## Statement of Environmental Effects (SEE)

**S 455 Application to Modify Existing Development Consent (LDA 2018 / 150)**

Property Address: 121 Bridge Road Ryde

Figure 1: Extract of drawing N01 detailing the 'as built' entry configuration.

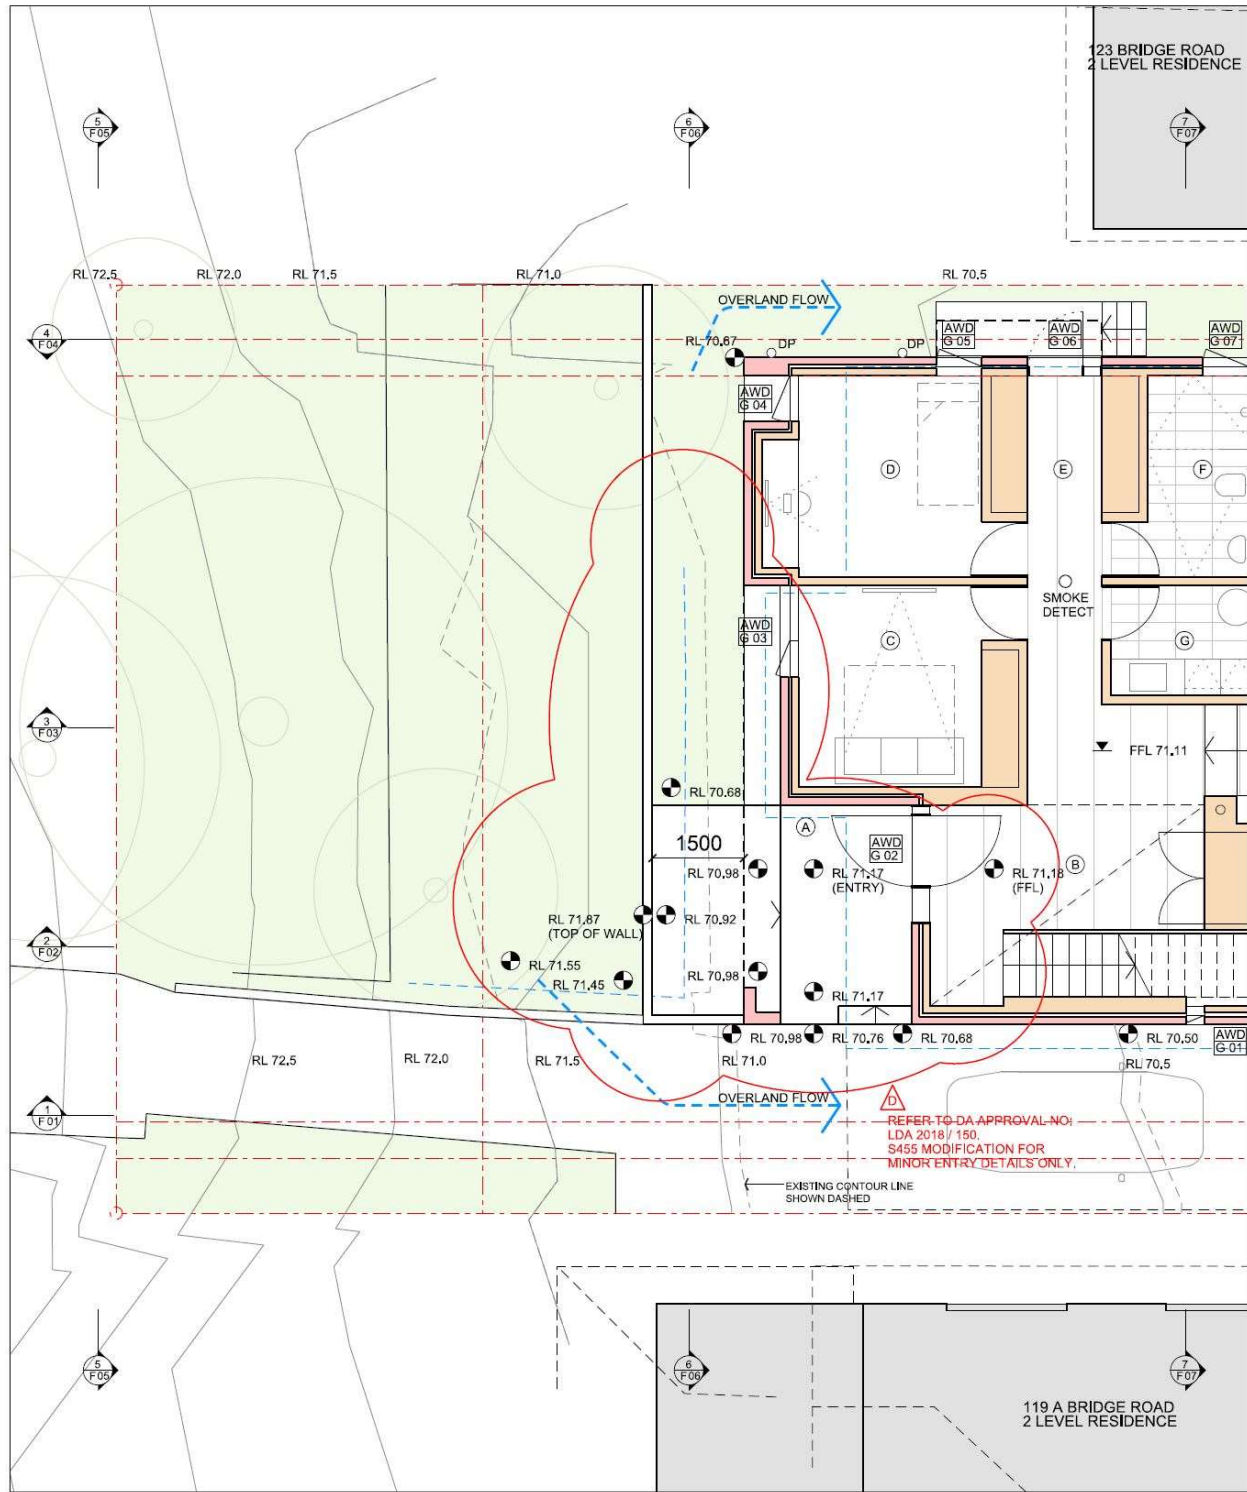
The entry detail has been modified to provide flood and overland flow protection and maintain a functional entrance to the residence. Refer to Architectural drawing 'N01 Proposed Entry Detail' in particular which provides specific detail of the 'as built' retaining walls, entry levels, set downs and location of columns and steps.

To achieve the entry configuration, one proposed timber screen was removed from the Eastern elevation of the entry at ground level and a 600 x 600 mm rendered column is included in the Southeastern corner of the entry, in lieu of the previously proposed circular metal column.
